DINTING VALE, GLOSSOP

TECHNICAL NOTE 001 – RESPONSE TO PLANNING APPLICATION CONSULTATION COMMENTS FROM DCC HIGHWAY AUTHORITY AND LEAD LOCAL FLOOD AUTHORITY

Drawing title:
Preliminary
Drainage Design

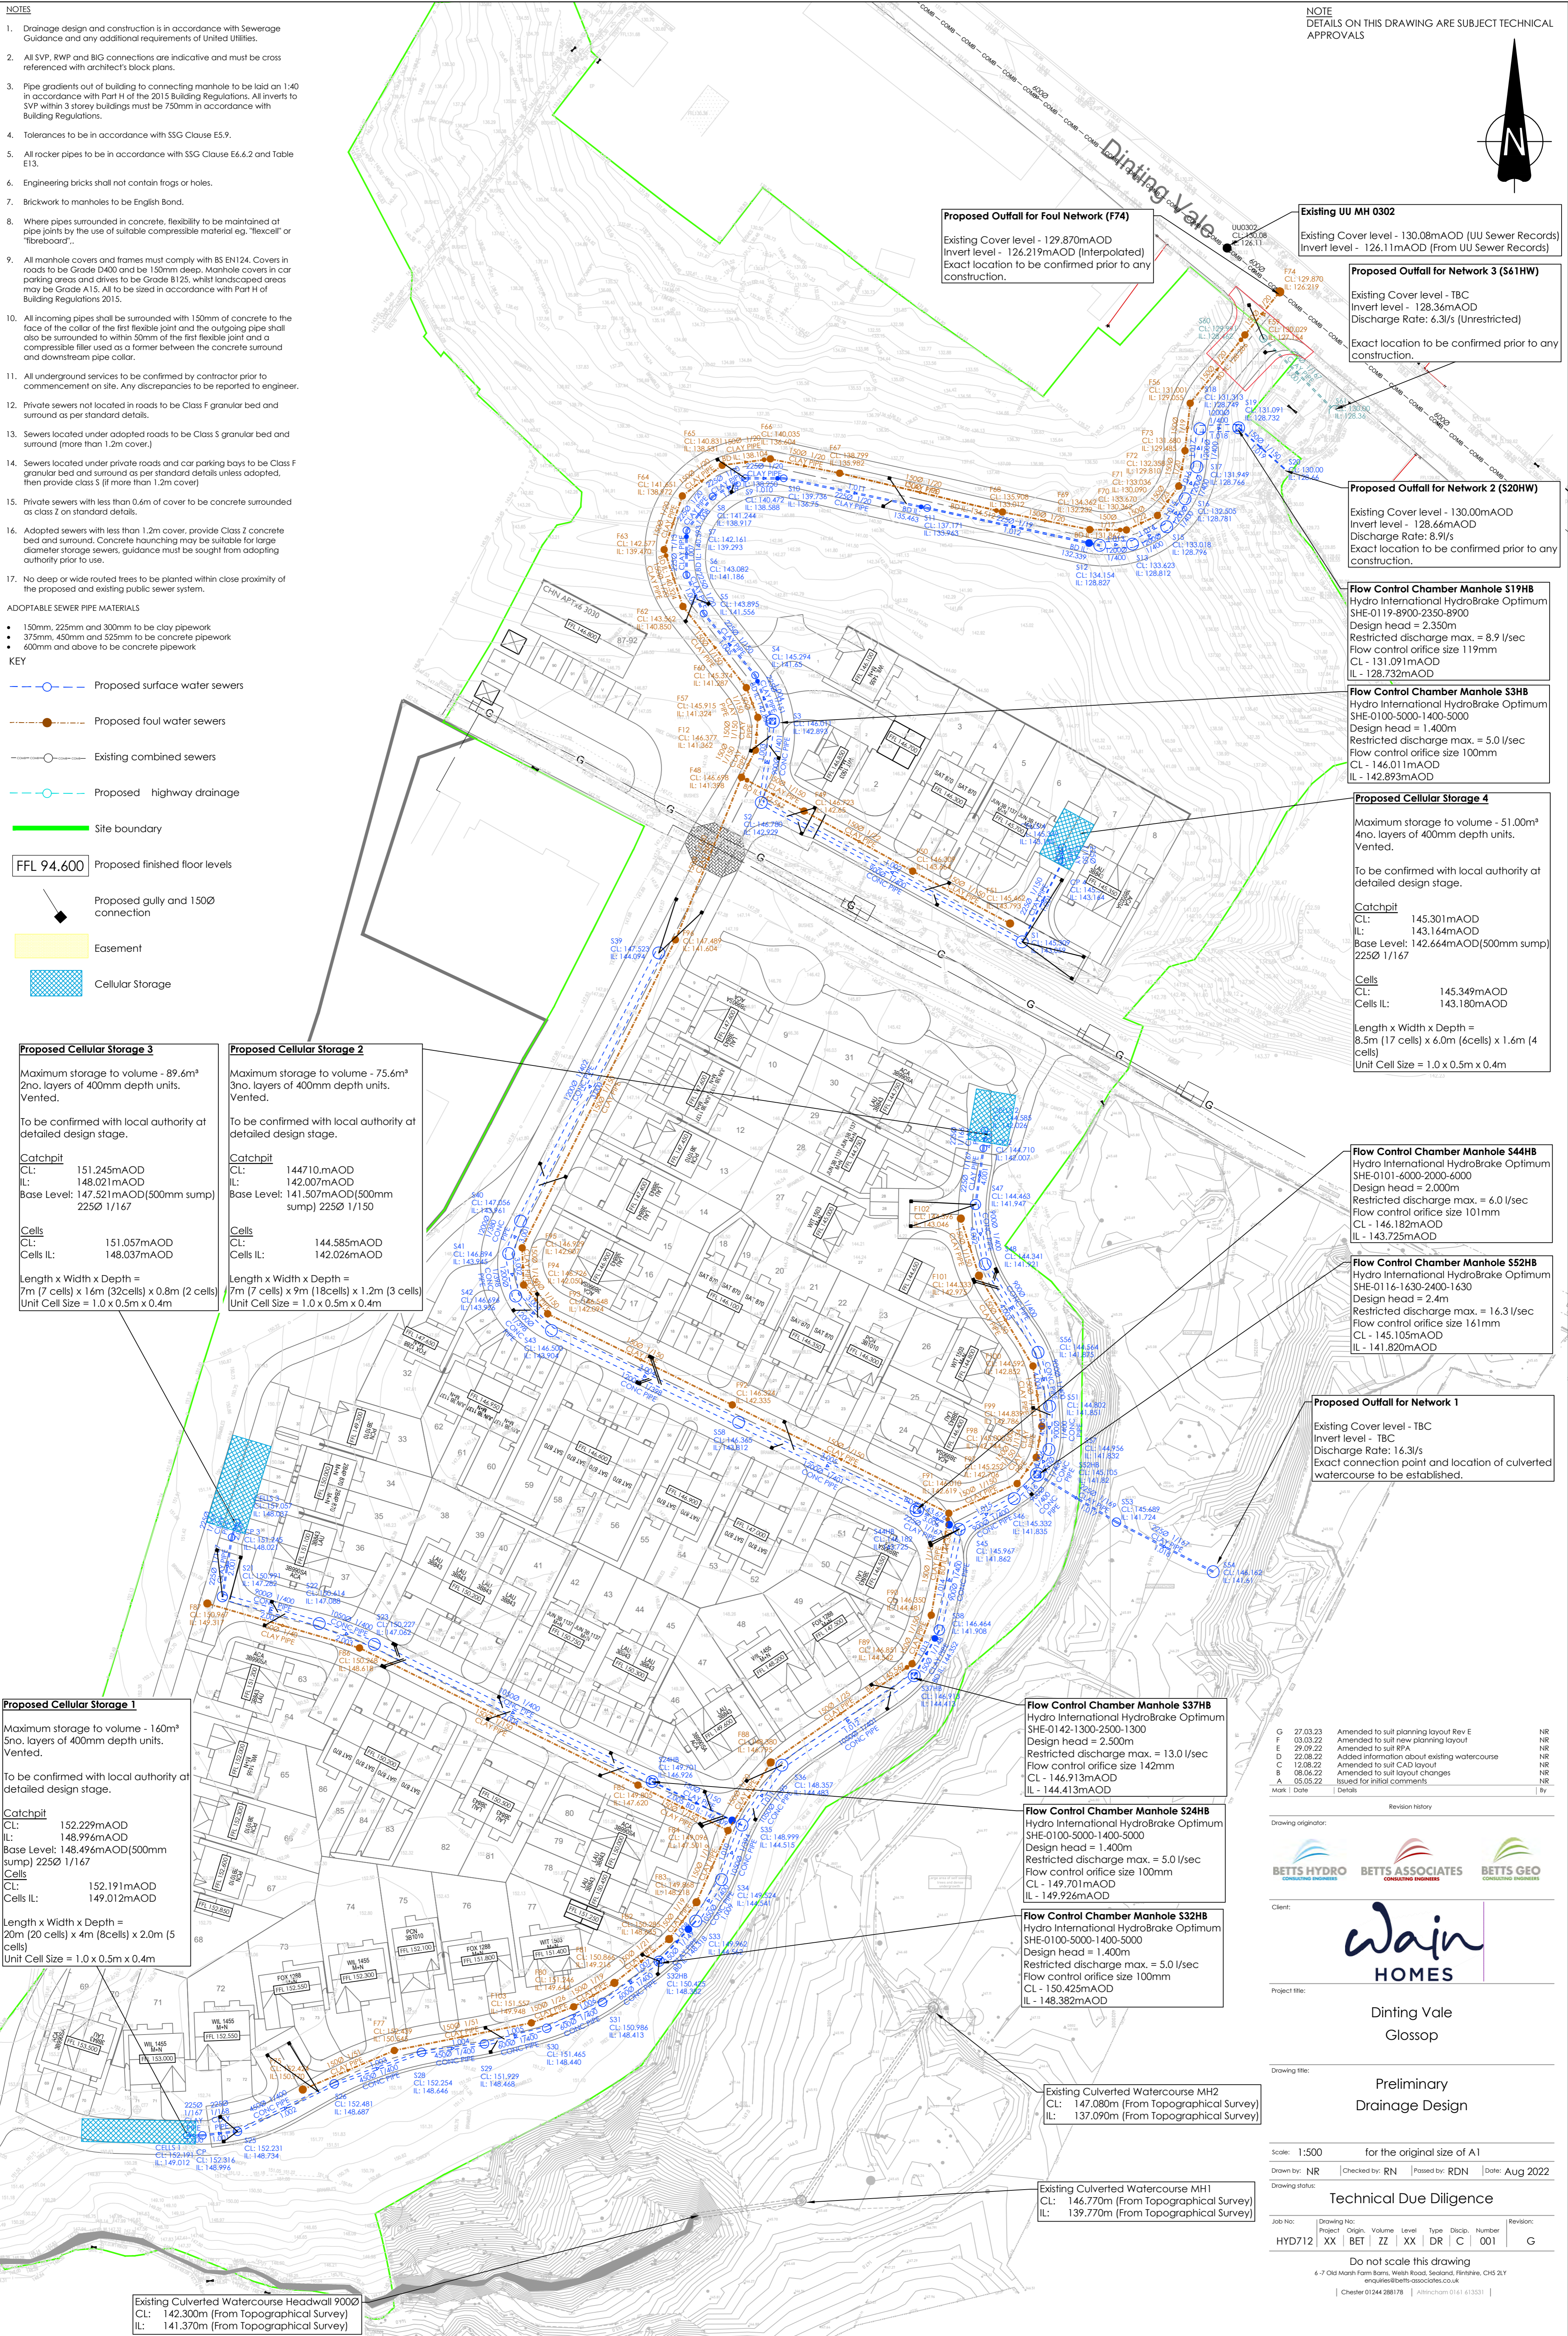
- Major developments should incorporate sustainable drainage systems unless there is clear evidence that this would be inappropriate (as per National Planning Policy Framework 169). A range of sustainable drainage techniques must be considered prior to or in conjunction with the planning layout.

- How the sustainable drainage systems integrate with the open space and green infrastructure should be described and what multifunctional benefits they provide should be stated, as per paragraph 59 of planning practice guidance (Aug 2022).

- The total discharge rate from the 3 outfall points into the watercourse to the east is greater than the calculated Q_{bar} rate given in section 7 of the report RSK. (August 2022). Flood Risk Assessment, 680312-R1(01)-FRA. The total discharge rate should either be Q_{bar} or a variable rate according to the 1% and 100% probability annual rainfall events.

- Evidence of permission for the 2 discharge points into the culvert within third party land.
- An indication of the condition and capacity of the open watercourse on north eastern boundary of the site

- An indication of the proposed impermeable area
- A quick storage estimate to show the required storage volume of surface water on site and an indication of the likely location. Calculations should include allowances for the current Environment Agency guidance for climate change and urban creep.

Sustainable Drainage Systems (SuDS) have been utilised where practical. Due to the underlying ground conditions, an infiltration drainage solution for the surface water cannot be achieved. In addition, the very significant topographic gradients on the site mean that some SuDS solutions are not feasible with slope stability of surface features being of serious concern; however, there is a swale along the western boundary, and a series of linked drainage basins designed to slow the flow, improving water quality by helping deal with the first 5mm of rainfall runoff and allowing time for natural losses to occur such as evaporation and infiltration (albeit limited). Tree pits are also proposed onsite, to provide opportunities for biofiltration and to create ecological corridors through the site.

Due to the very steep topography, there is a need for the majority of stormwater storage to be below ground within over-sized stormwater storage pipes. The current drainage design provides stormwater storage for rainfall events up to and including the 100 year return period with a 45% allowance for climate change.

The surface water discharge rate has been re-calculated to reflect the current favoured greenfield runoff methodologies and has been updated on both the Preliminary Drainage Layout and the Flood Risk Assessment by RSK.

The outfalls have been rationalised with the northern outfall being located within the application site and the other two outfalls consolidated into one – this is within Council owned land, and it is understood that Wain Homes are liaising with High Peak on this connection.

The FRA confirms there to be sufficient capacity within the receiving watercourse for a connection at QBar, although no detailed hydraulic modelling of the culvert capacity has been undertaken in terms of the impact of climate or potential for blockage.

The current drainage design proposals on the Preliminary Drainage Strategy drawing have been sized and detailed based using Microdrainage software and include appropriate allowances for both climate change (45% increase in peak rate of rainfall) and urban creep (10%).
